**Approved baseline and monitoring methodology/
methodological tool clarification response form
(Version 02.0)**

Date and number of Panel/ WG meeting:	5–8 May 2014, SSC WG 44
Title/Subject of the request for clarification:	Clarification on monitoring of emission reductions for projects involving power factor correction equipment using AMS-II.C
Reference number of the request for clarification:	SSC_708
Exact reference (number, title and version) of the methodology or methodological tool to which the request for clarification applies:	AMS-II.C “Demand-side energy efficiency activities for specific technologies --- Version 14.0”
Fast track or Regular track:	<input type="checkbox"/> Fast track <input checked="" type="checkbox"/> Regular track

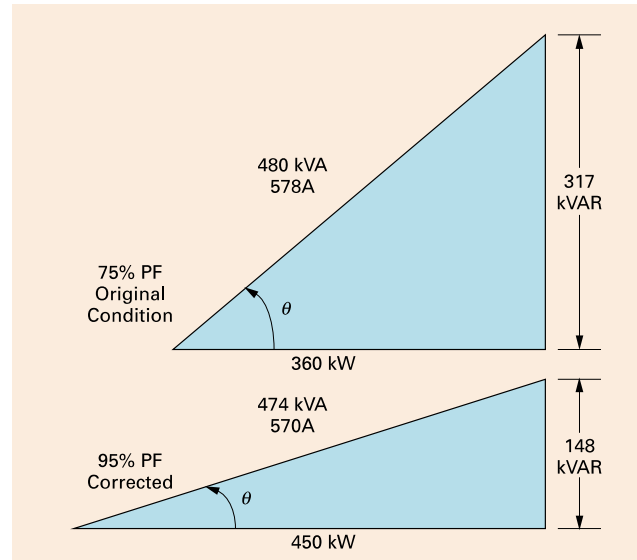
1. **A reduction in kVA demand due to PF improvement may not necessarily translate into emissions reductions:** A methodology to quantify emission reduction attributable to PF correction equipment may not be that straight forward as proposed by the authors which only accounts impact on grid in terms of loss reductions due to placement of capacitor in industrial facility. Improving the power factor does reduce the losses the but may not be necessarily reduce the active power (kW) production – which is governed by fuel-input and hence associated with emission reductions. A reduction in kVA demand due to capacitor placement may not necessarily translate into savings in kWh demand and hence may not lead to kWh electricity production avoided at the generation side. Since the generators, power cables and transformers are rated in kVA capacity (not in kW capacity) and due to the fact that power factor on a kW load reduces kVA ($kVA = kW/PF$), PF correcting capacitors increase system current-carrying capacity. In other words, by improving power factor, generator/transformer can deliver more real power (kW) to the loads. This case is obvious where the system is already overloaded or constrained to meet increase in kW demand, power factor correction could avoid the need for additional generation/transformer capacity. This is illustrated by the example below. So, loss reduction claimed due to power factor correction may not eventually translate to reduction in electricity generation and emissions reductions thereof.

Example:

- a. An industrial facility has a 500 kVA, 3 phase transformer operating near capacity. It draws 480 kVA or 578 A at 480V [$(\sqrt{3} \times \text{voltage} \times \text{current}) / 1000$]. The present PF is 75% and the actual working load is 360 kW (480×0.75).
- b. It is desired to increase the production by 25% which would require additional 450 kW working load to be supplied. To supply 450 kW demand at 75% power factor load, addition of a new 600 kVA transformer would be the solution. However, a

better solution would be to improve the power factor from 75% to 95%, and release enough capacity to accommodate the increased load

- c. Similarly, at the generation end (which is also rated in kVA) , improvement in power factor at demand side may release the generation capacity and hence would supply more actual power (kW) to the grid.

'A reduction in kVA demand due to capacitor placement may not necessarily translate into savings in kWh demand and hence may not lead to kWh electricity production avoided at the generation side.' The PF intervention will take place at the site of the industrial electricity consumer. The capacitor banks will generate the kVAr demand locally and less kVA will be required to be delivered from the transmission and distribution system. The reduction of kVA demand at the industrial electricity client will result into a reduction of energy losses in the transmission distribution system. The reduction of losses will require the power generator to generate less power. Consequently, PF intervention translates into energy savings.

When you improve the PF at the site of the industrial electricity consumer, kVAr is generated locally and less kVA is to be supplied by the system. This however does not change the actual load of the facility (i.e. kW and kWh).
